ADDENDUM NO. 2

Westside Library Relocation Project

Addendum #2

Westside Library Expansion Project

75-22614-07 WEST BUILDING -EXTERIOR ELEVATIONS

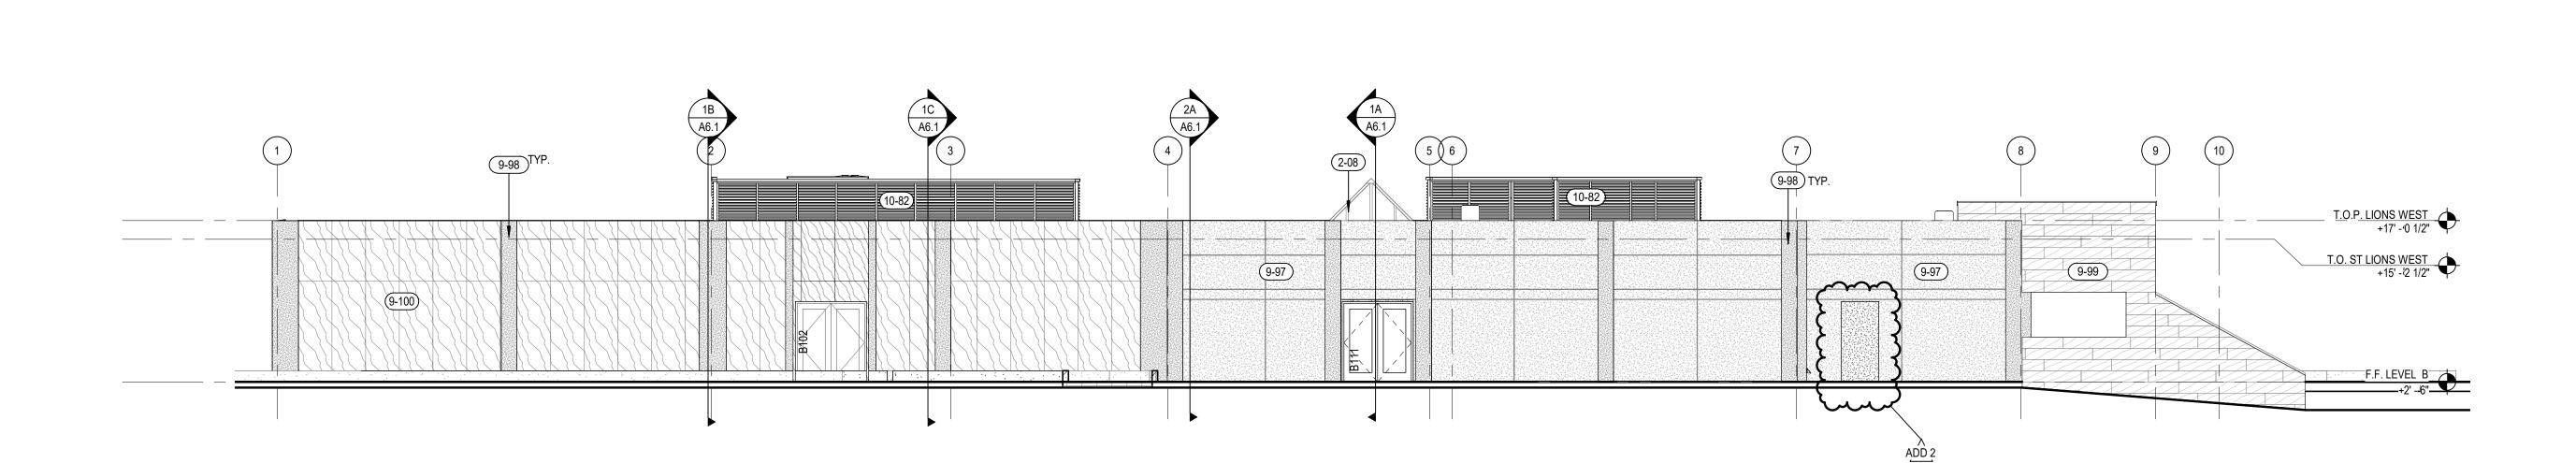
ITEM A-2.07 <u>SHEET A4.3 – WEST BUILDING – EXTERIOR ELEVATIONS</u>

UPDATING EXTERIOR ELEVATIONS W/ WALL INFILL AND INDICATING PLASTER.

75-22614-07 DOOR SCHEDULE

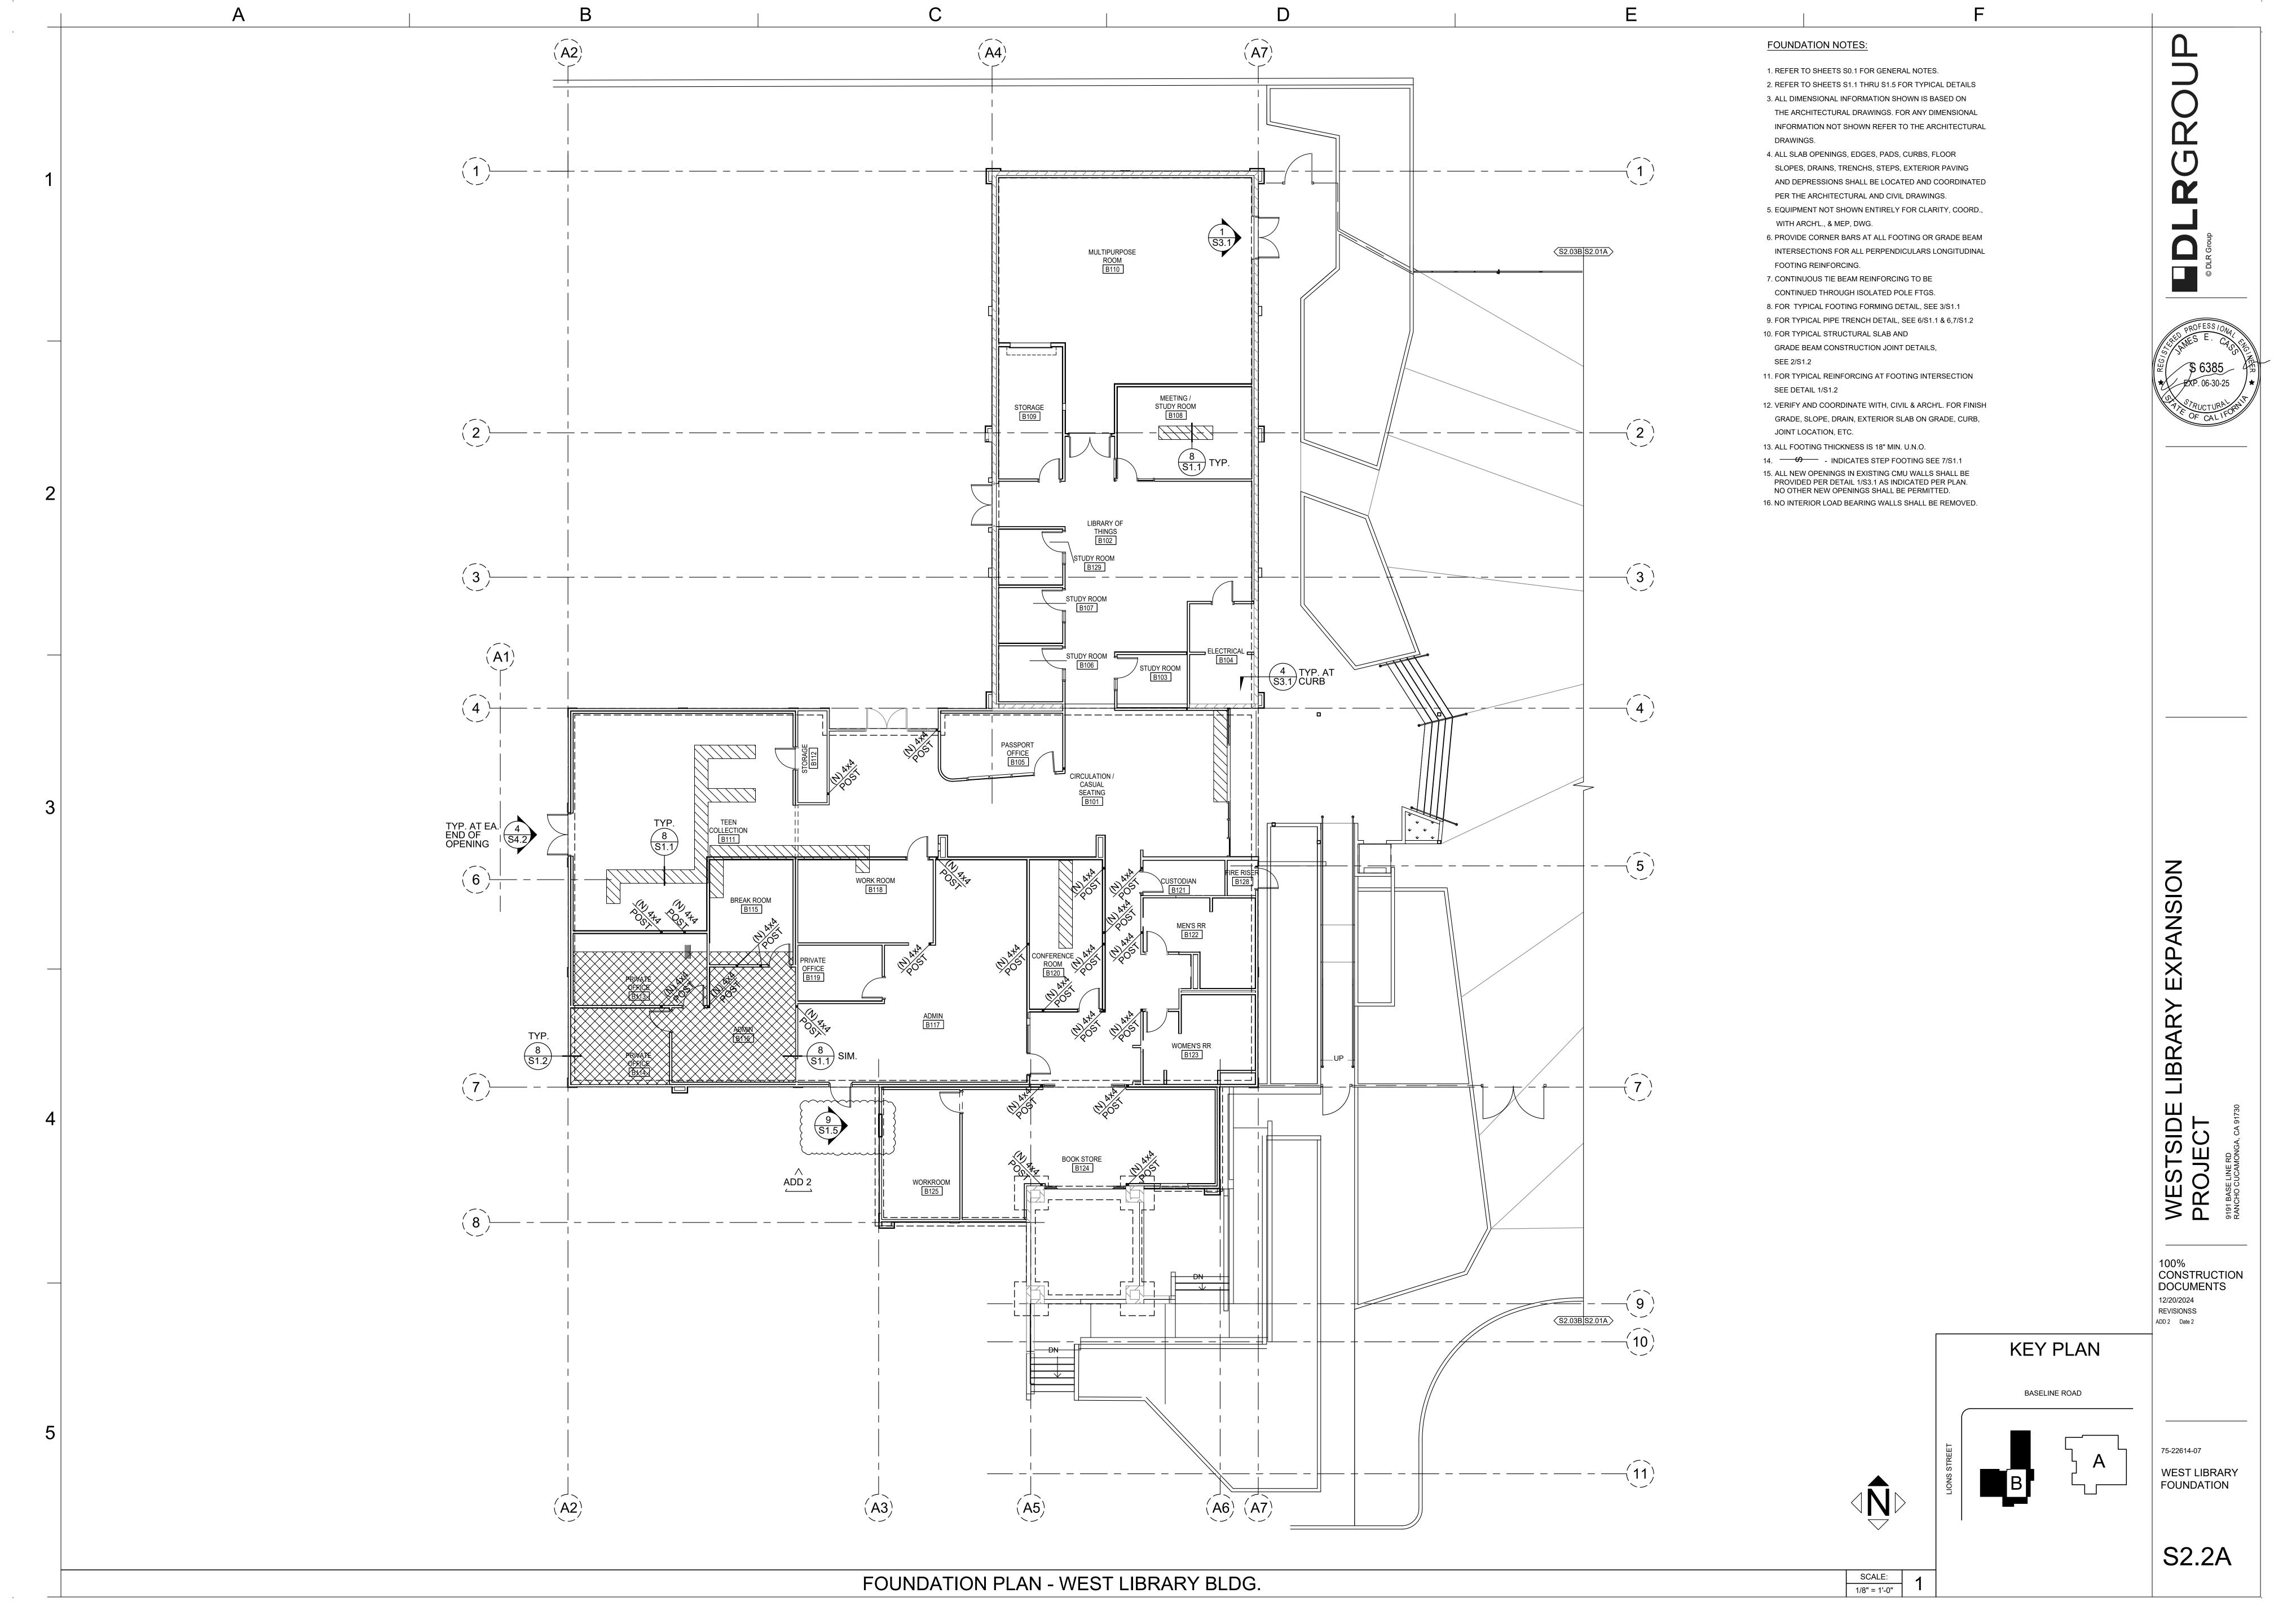
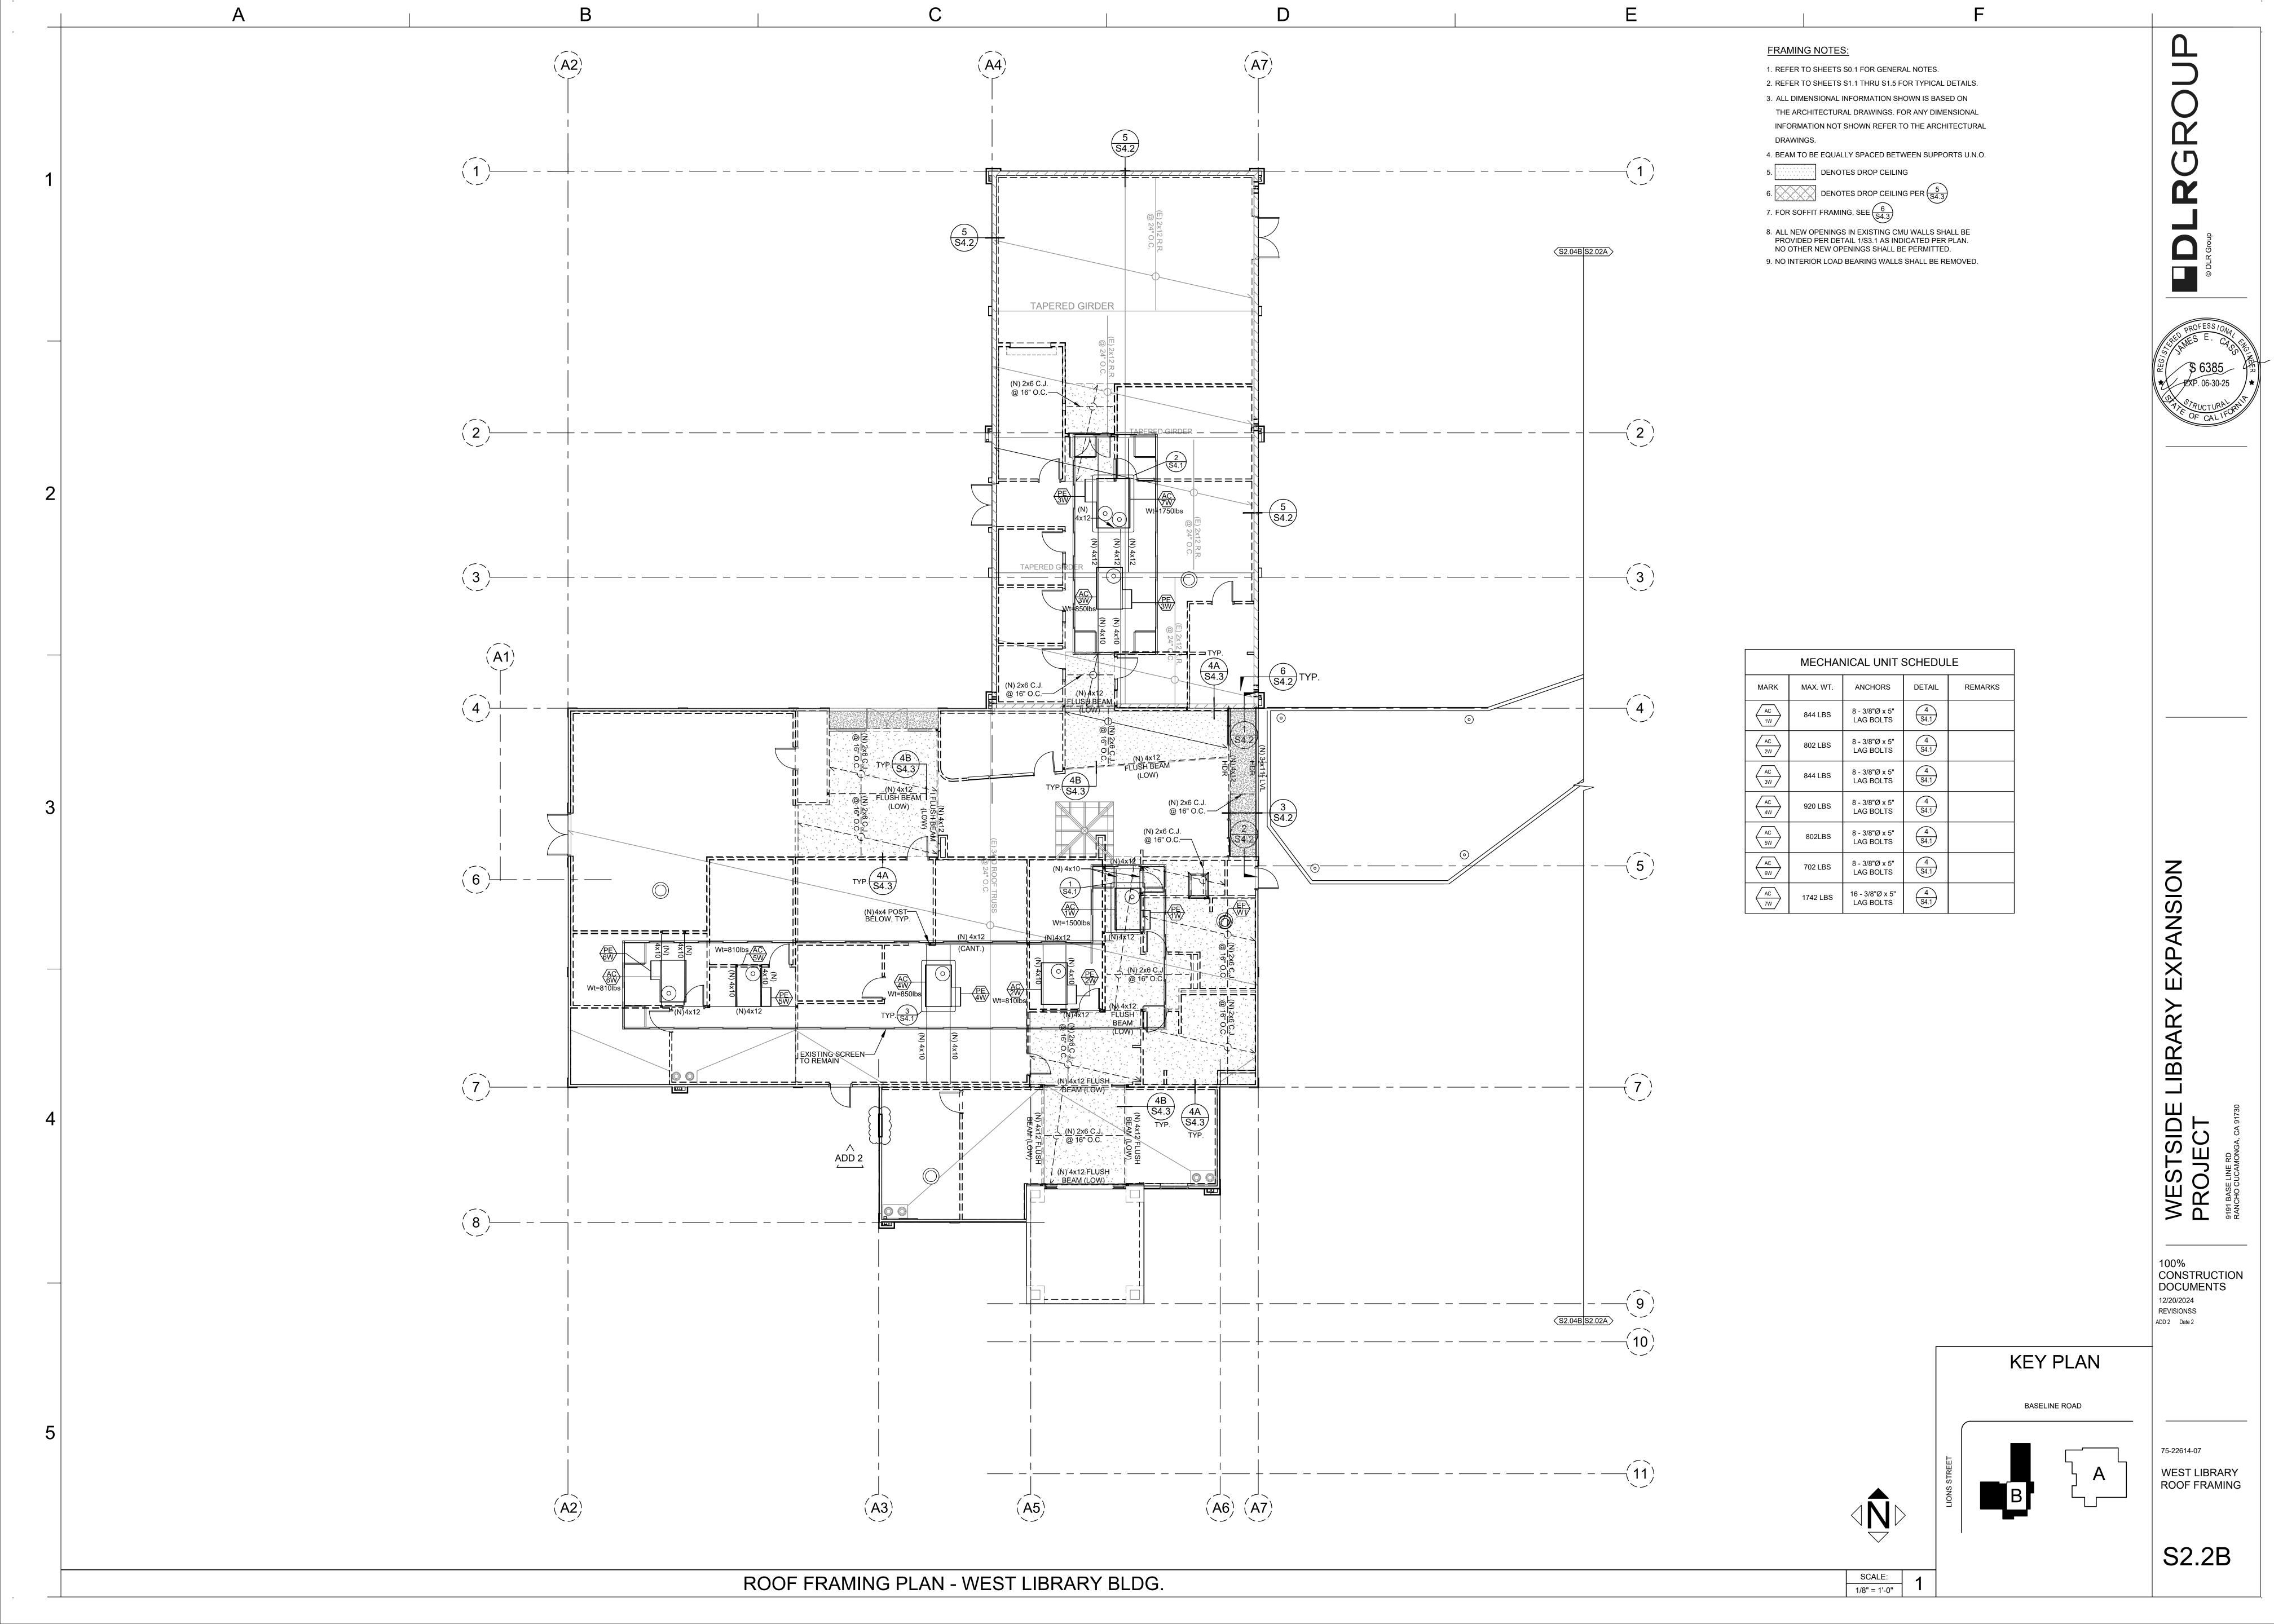
ITEM A-2.08 SHEET A8.1 – DOOR SCHEDULE & STOREFRONT ELEVATIONS

1. REMOVING DOOR B124C FROM SCHEDULE.
